Subject: LU Case # 11-153362 LDS ENM
HO Case # 4120015

Re: Appeal Additional Evidentiary Response-revised

Re: Appeal of Land Use Decision to Deny a Four-lot Subdivision
Located at SE Berkeley Way and SE Cesar E Chavez Blvd.
LU 11-153362 LDS ENM (HO 4120015)

Subject: LU Case # 11-153362 LDS ENM
HO Case # 4120015
Additional Evidentiary Response – On-street Parking Analysis

Figure 1
Enlarged View of proposed lot layout at
SE Berkeley Way.

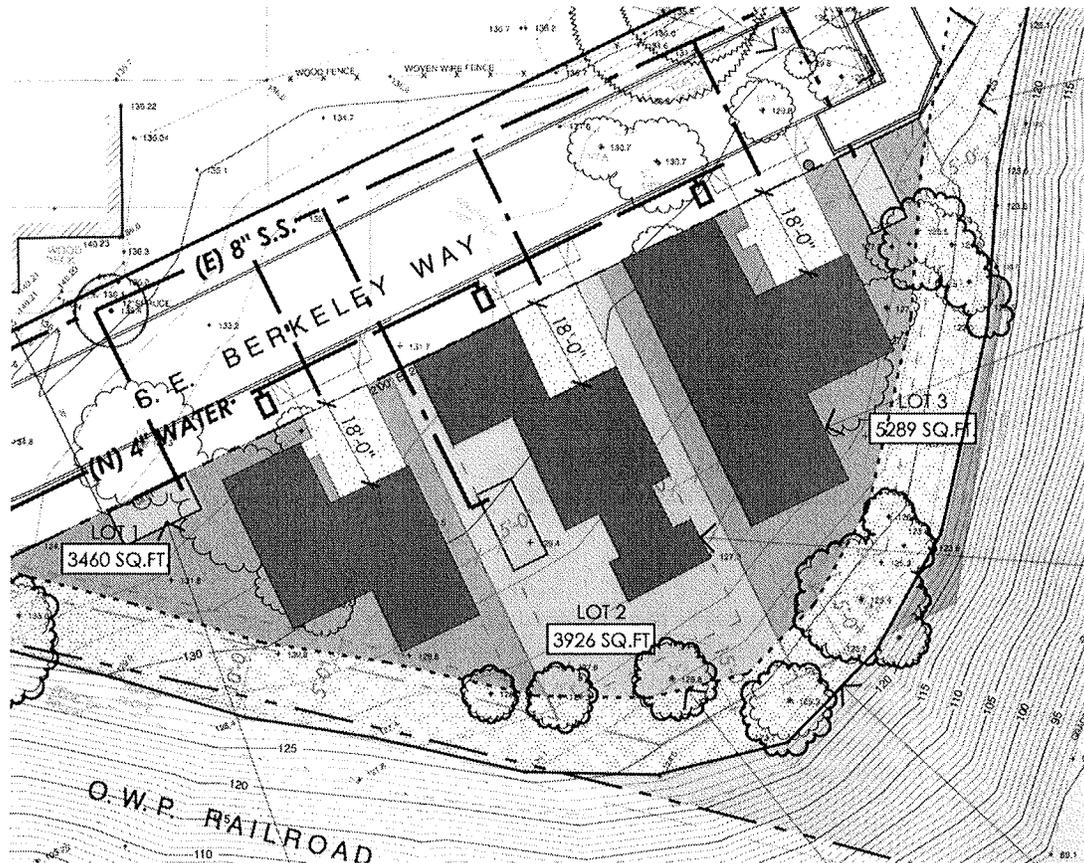
"PCC33.641 requires the applicant to provide evidence in the record sufficient to demonstrate that the identified evaluation factors are satisfied. One of the evaluation factors requires the applicant to review on-street parking impacts of the proposed development. The hearing officer found that the applicant failed to provide adequate evidence in the record."

On-site parking is accommodated on each of the proposed lots. (Lot 4 fronting on SE Tenino is not affected, as it does not abut the SE Berkeley Way Right of way.) A minimum of two on-site parking spaces can be accommodated with a typical 18-foot setback and a 16-foot wide driveway for the lots abutting SE Berkeley Way. Up to four parking spaces could be accommodated on each site should a two-car garage be developed in conjunction with the aforementioned driveway. (See figure 1)

This allows up to four (4) on site parking spaces limiting the on-street parking impact.

FIG. 4

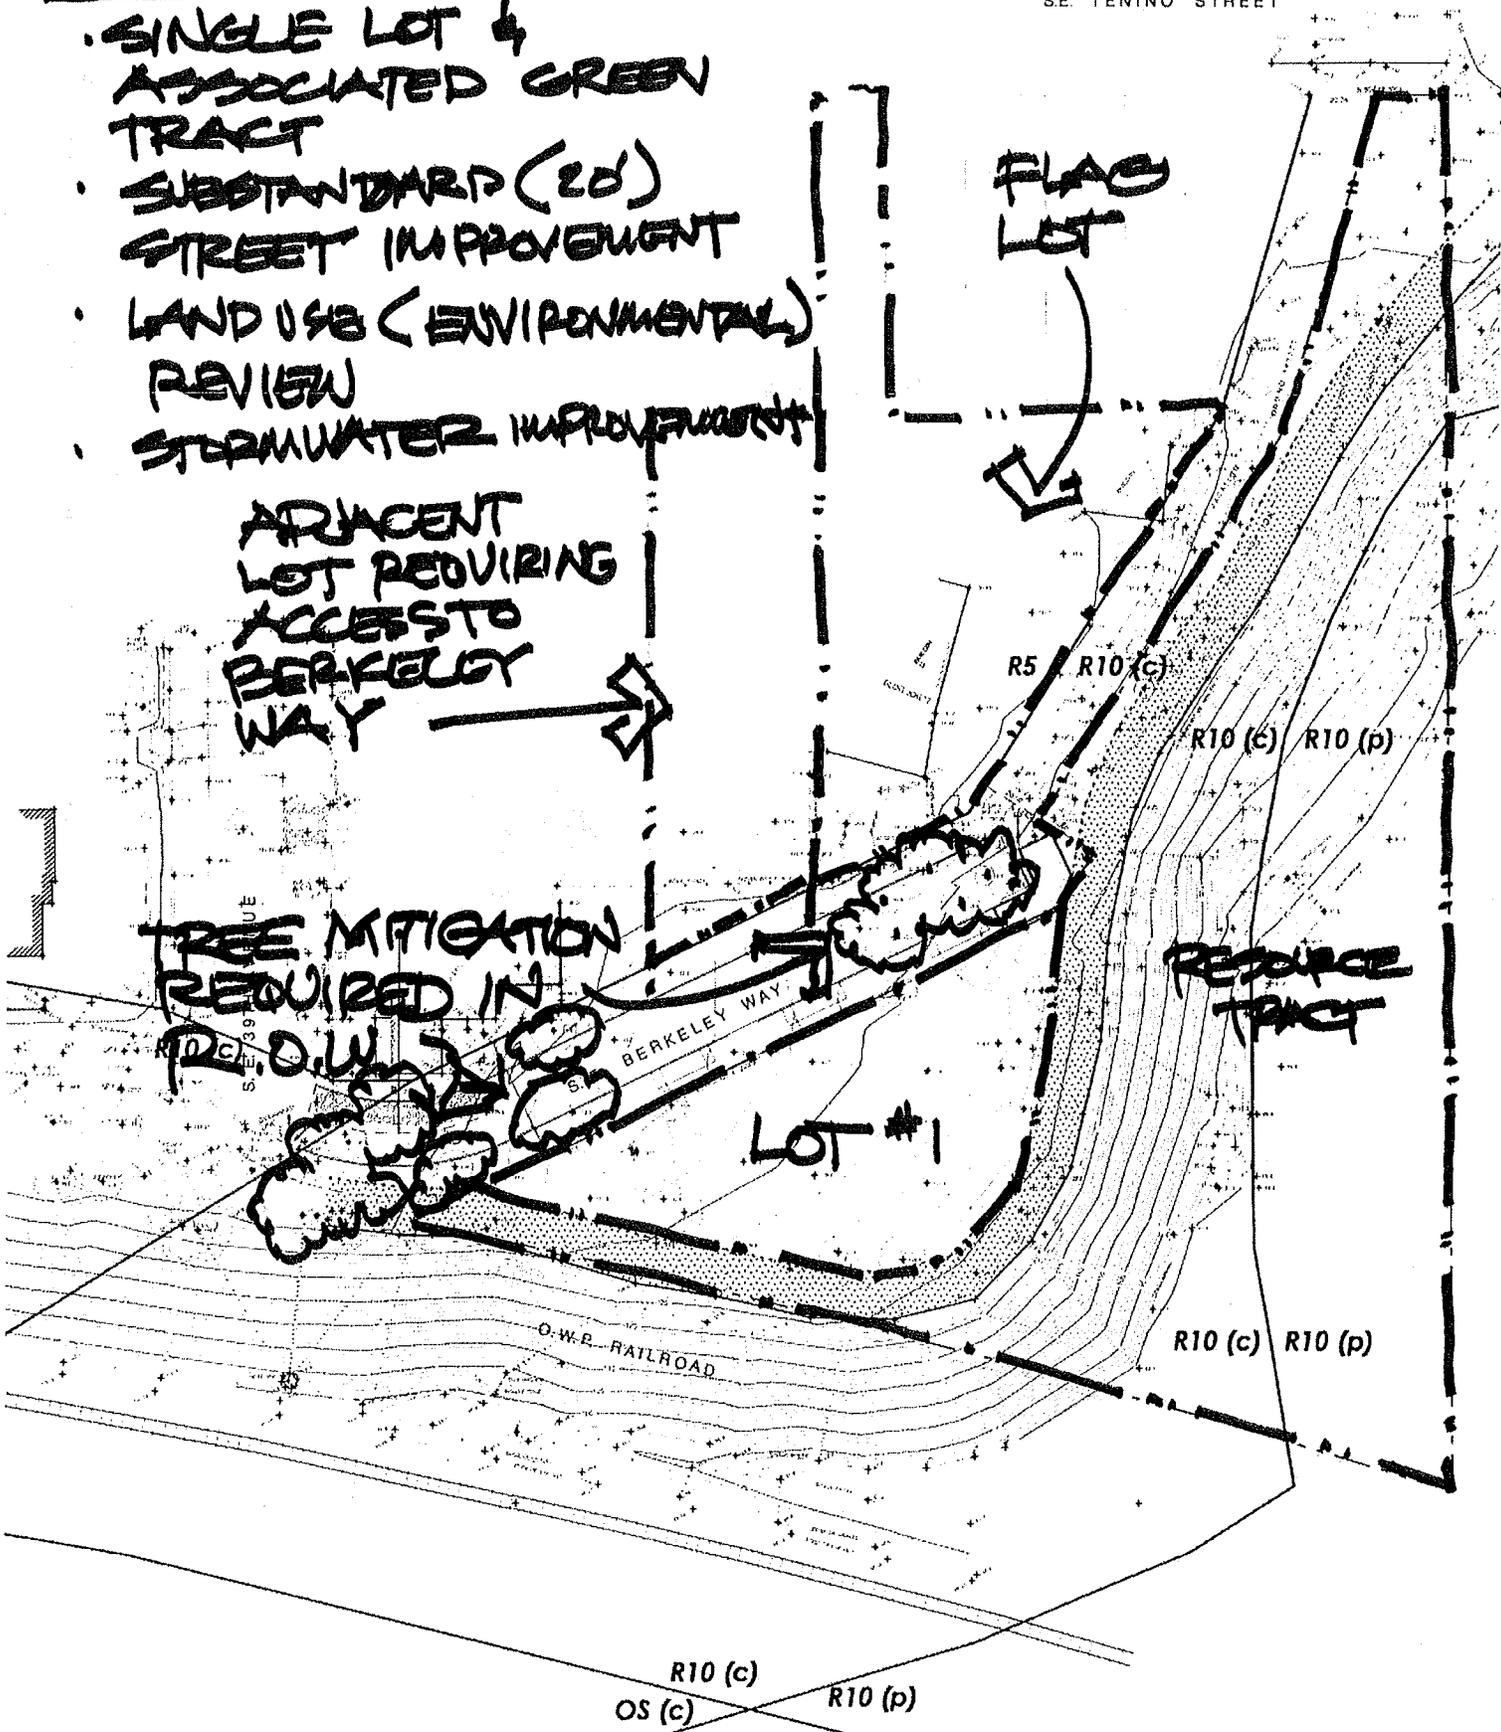
In addition, I would submit that the appellant has not been thorough and has been misleadingly selective in the alternatives he submits. For example, Alternative #1 shows the bluff plateau area being developed with only one house. Yet his Table 1: Probable Project Cost, includes \$120,000 for street right-of-way improvements for just one house. It is not at all clear why a more than 200 foot long street improvement would be needed to develop one lot that would have easy access from SE Cesar Chavez. While there is a potential land-locked lot on SE Berkeley way north of the site, when the owner of that lot decides to develop it, he/she would then be responsible for bearing the cost of right-of-way access improvement.

Alternate 1 (figure 4) reflects the applicant's initial exploration of a single-family residence with the required "substandard" street improvements including required storm water management for said improvements. Street improvements were required to allow access to the applicants parcel as well as a lot on the north side of Berkeley Way. Design, Infrastructure (street improvements and storm water management) and land use application / approval cost estimates far exceeded the value for the land and the ability for the applicant to build a single-family residence. A single-family residence was not practicable.

FIG. 5

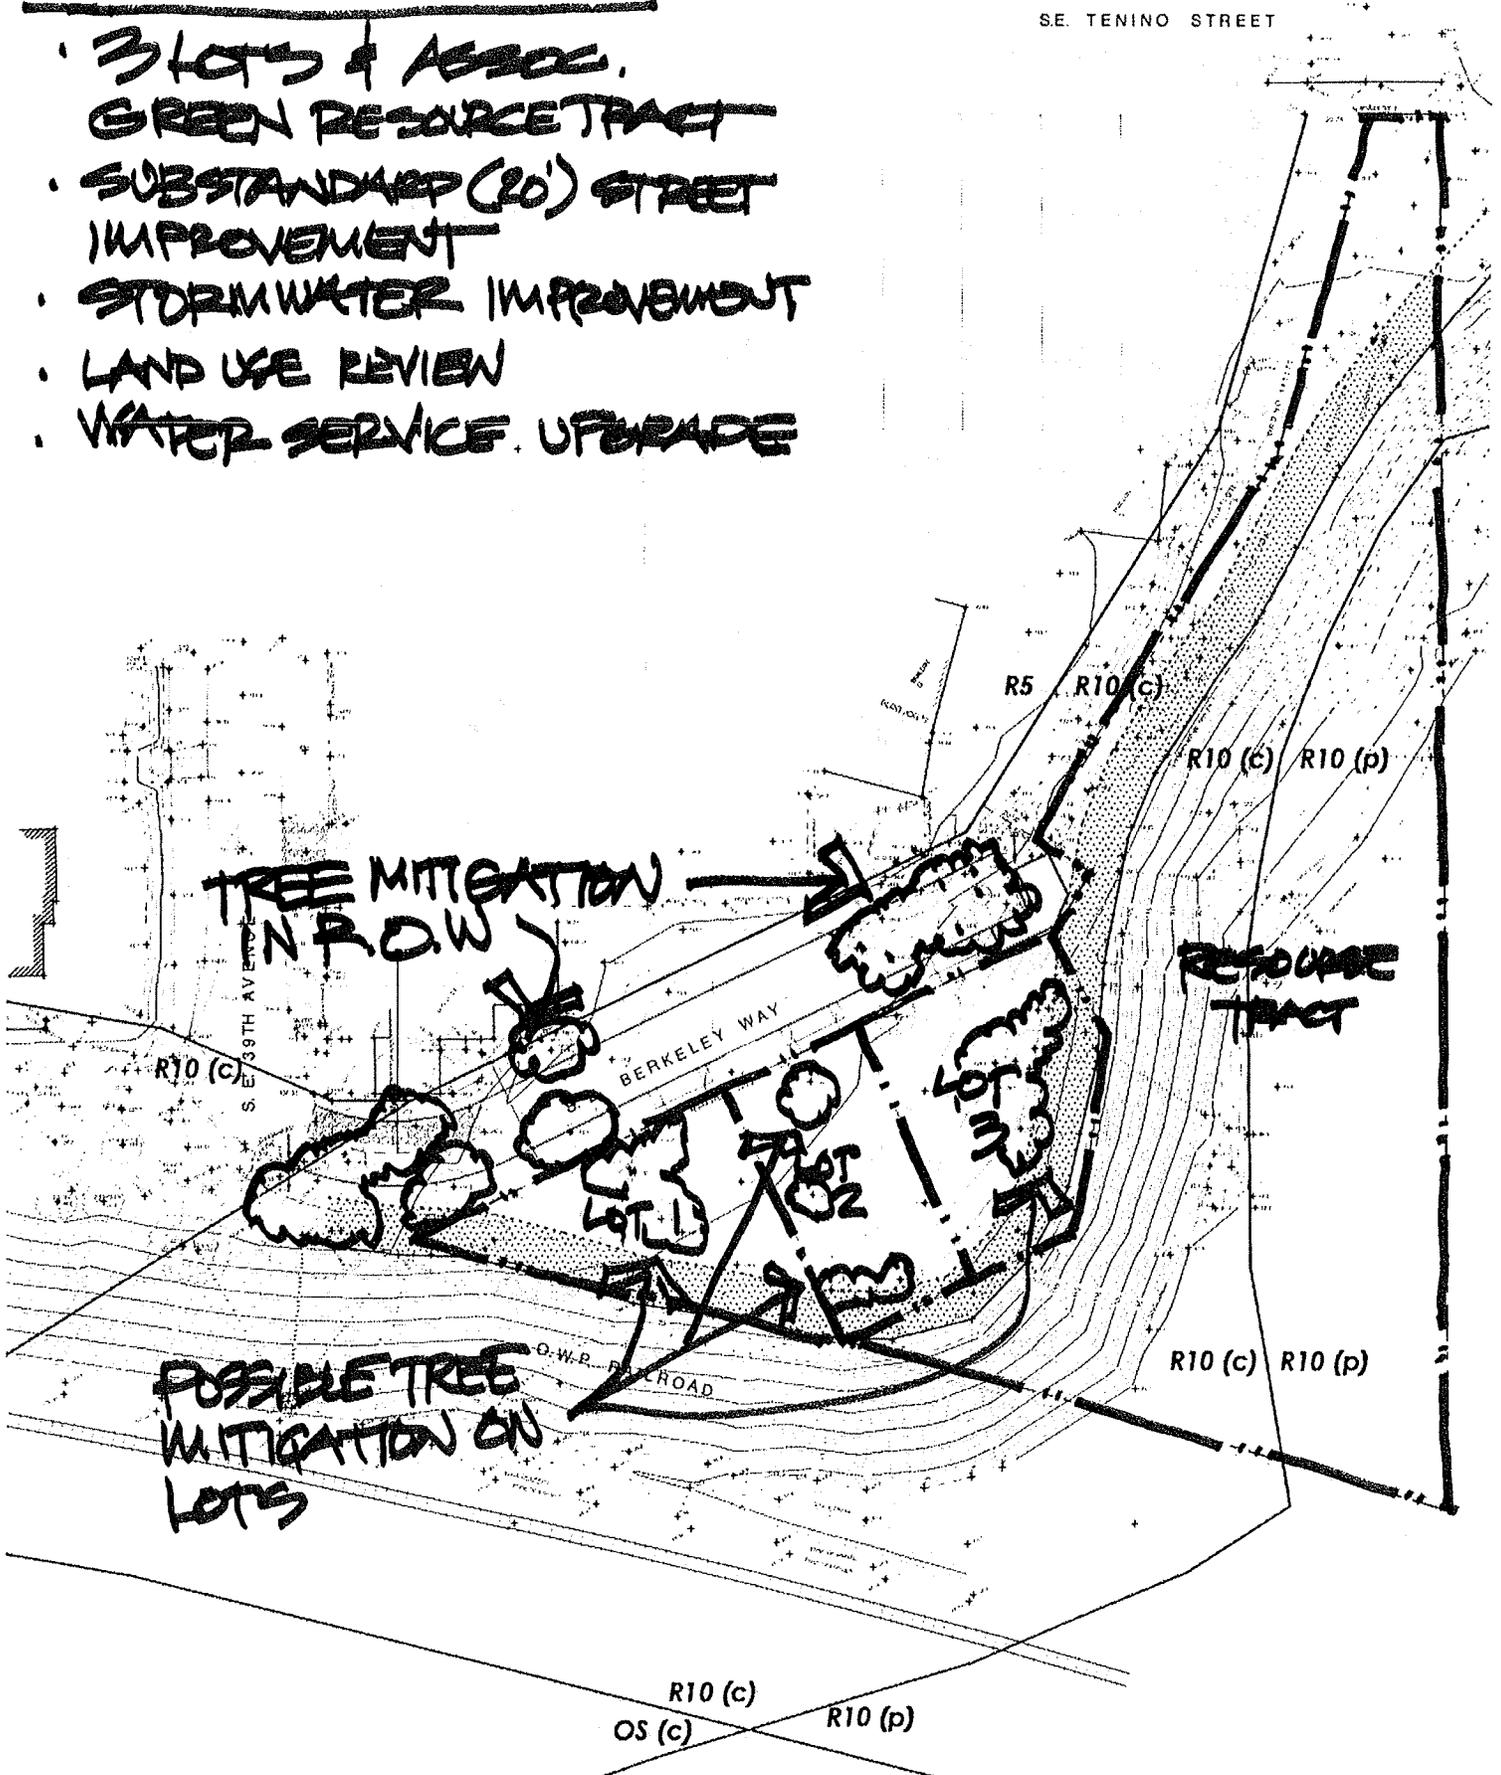
"PCC 33.430.250 A.1, A.3 and A.4 require an applicant to conduct an environmental alternatives analysis related to locations, designs and construction methods. The alternatives analysis must consider whether or not proposed alternatives are practicable and then determine which of the practicable alternatives creates the least significant detrimental impacts upon identified environmental resources and functional values. The Hearings Officer found that the applicants submissions failed to provide substantial evidence to satisfy the PCC 33.430.250 A.1, A.3 and A.4 approval criteria."

The applicant submitted a three-lot land use action in 2007 (**Alternate 2** – figure 5) that was withdrawn due to more clearly identified costs of the required infrastructure improvements, including providing water to the lots and upgrading a portion of the water main in SE Caesar Chavez Blvd. The costs outlined in table 1 reflect a reduction of infrastructure costs per lot between alternative 1 and alternative 2 of nearly 50%. However, the increase of water service upgrades is a required additional expense added to multiple lot scenarios not required for the single-family residence alternative.
